RESPONSE TO REQUEST FOR ADDITIONAL INFORMATION

APR1400 Design Certification

RAI No.: 370-8450

SRP Section: 15.06.03 - Radiological Consequences of Steam Generator Tube Failure (PWR)

1. Figures with dynamic behavior of important Nuclear Steam Supply System (NSSS) parameters for the CESEC-III analysis that corresponds to the limiting MDNBR analysis are shown in Figure 1 through Figure 4.

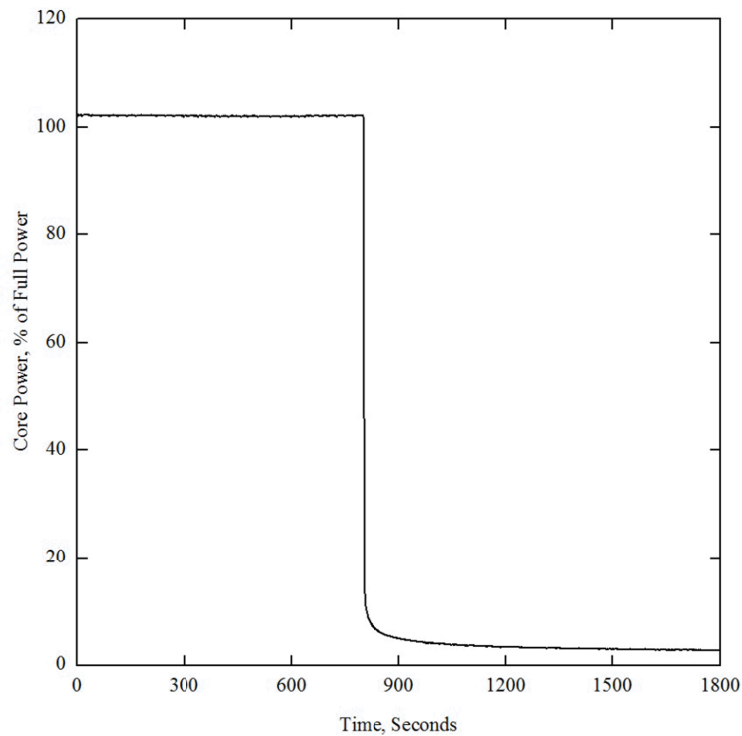
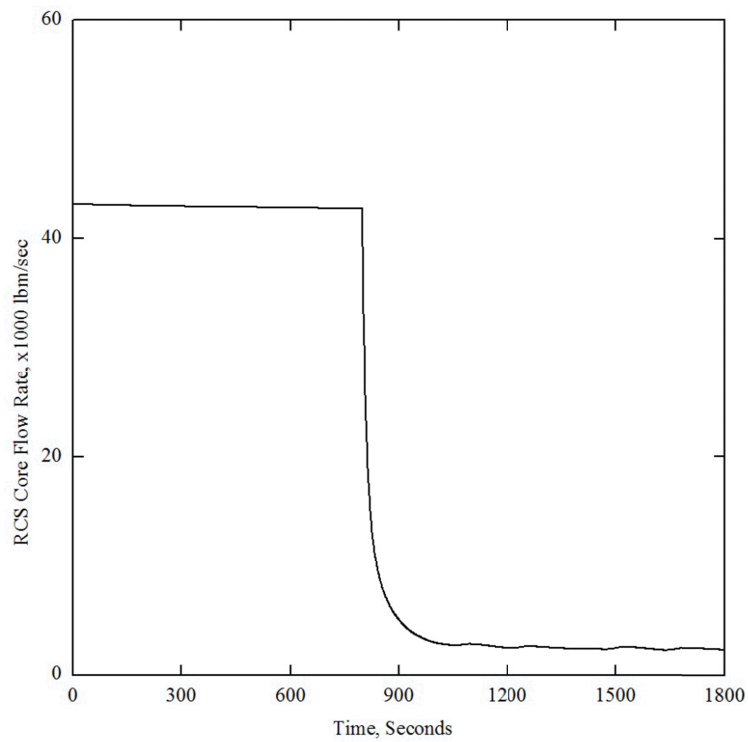
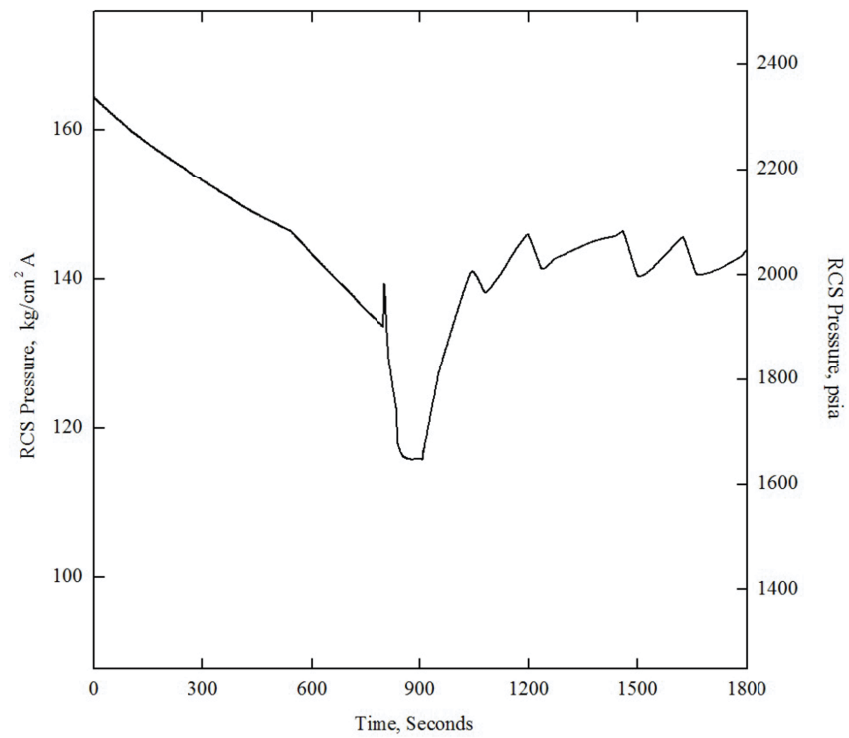
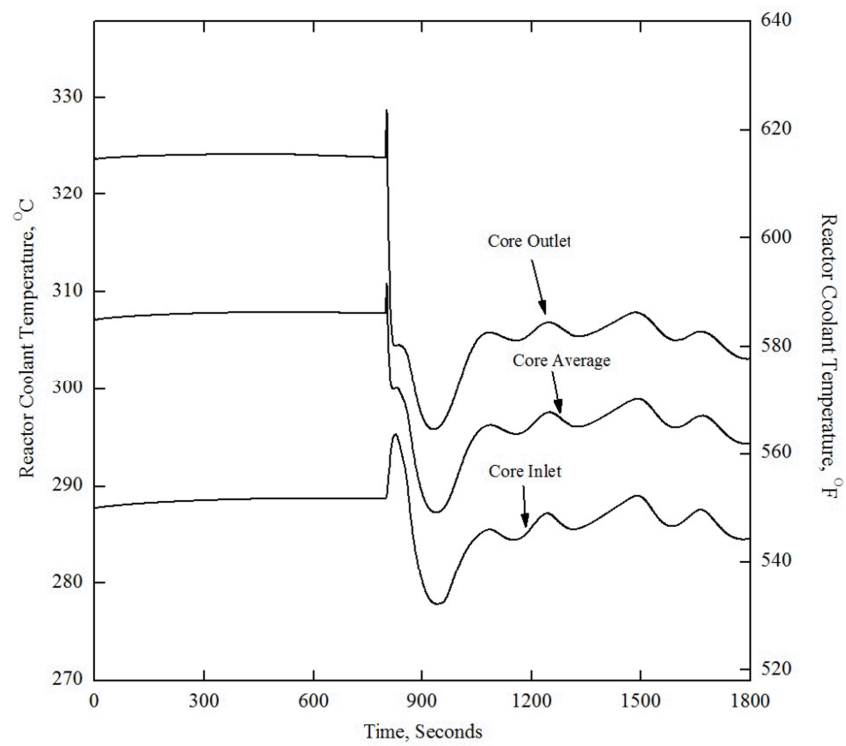
1. Figures that show dynamic behavior of important Nuclear Steam Supply System (NSSS) parameters for the CESEC-III analysis that corresponds to the limiting MDNBR analysis.
2. A table that presents the chronological list of events that occur during the steam generator tube rupture event that corresponds to the limiting MDNBR analysis. This table should include, at a minimum, the time and associated setpoint of any reactor protection system (RPS) or engineered safety features (ESFs) actuation, and any significant operator actions.

Figure 1 SGTR with Concurrent LOOP corresponds to MDNBR:
Core Power vs. Time

Figure 2 SGTR with Concurrent LOOP corresponds to MDNBR:
RCS Core Flow Rate vs. Time

Figure 3 SGTR with Concurrent LOOP corresponds to MDNBR:
RCS Pressure vs. Time

Figure 4 SGTR with Concurrent LOOP corresponds to MDNBR:
Reactor Coolant Temperature vs. Time
